# Comments on the Justification for the Lower Churchill Transmission Project (Labrador-Island Transmission Link)

submitted to the  
Canadian Environmental Assessment Agency  
Comprehensive Study on the Lower Churchill  
Transmission Project

on behalf of Grand Riverkeeper Labrador Inc.

Philip Raphals  
Executive Director  
Helios Centre

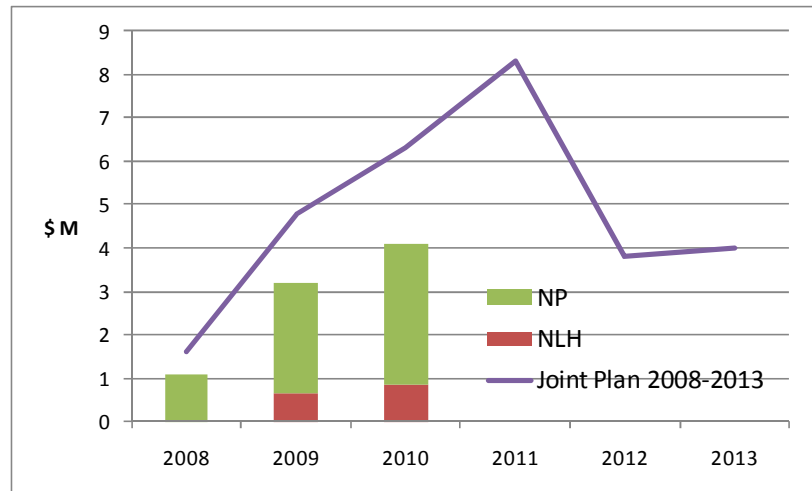
The Proponent states that “To date, the *response* to CDM programs and initiatives has been modest and lagging targets.”<sup>21</sup> (emphasis added) However, it fails to point out that the **programs and initiatives themselves** have also been modest and lagging targets.

The following chart, drawn from my April 13, 2011 submission to the Joint Review Panel,<sup>22</sup> demonstrates that CDM funding by NLH and by NP lagged far behind that which was projected in their Five-Year Joint CDM Plan.

This is not particularly surprising: Most utilities perform very poorly when they first begin to pursue CDM savings. What is surprising is that, based on its admittedly poor performance in the first years of its CDM program, **NLH has chosen to exclude consideration of CDM savings as a resource in its 50-year power plan.** I am not aware of any other utility in North America that has so blatantly disregarded CDM as a resource.

LIVE CHARTS - CRUDE OIL CHART AND LIVE OIL PRICES

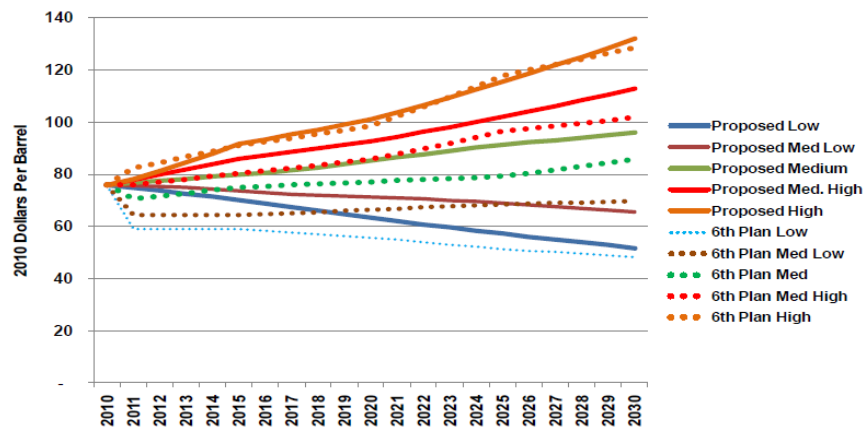
MHI pointed out this uncertainty as well, writing:

It is clear there is much uncertainty related to the pricing of fuel for thermal-based power generation. Different scenarios can and should be run and compared, but **the results related thereto often have a short shelf life.** While the prospect of raising the necessary capital to finance and construct the Infeed Option may be daunting, **the uncertainty associated with forecasting the price of fuel for thermal generation over the long term might be, and likely is, even more so.** (emphasis added)<sup>63</sup>

The PIRA high and low forecasts have not been made public, so to get an idea of the extent of the typical spreads between high and low oil price forecasts, I had to look to other sources. The following chart presents the oil price forecast from the Northwest Power Planning Council's 2009 Power Plan.
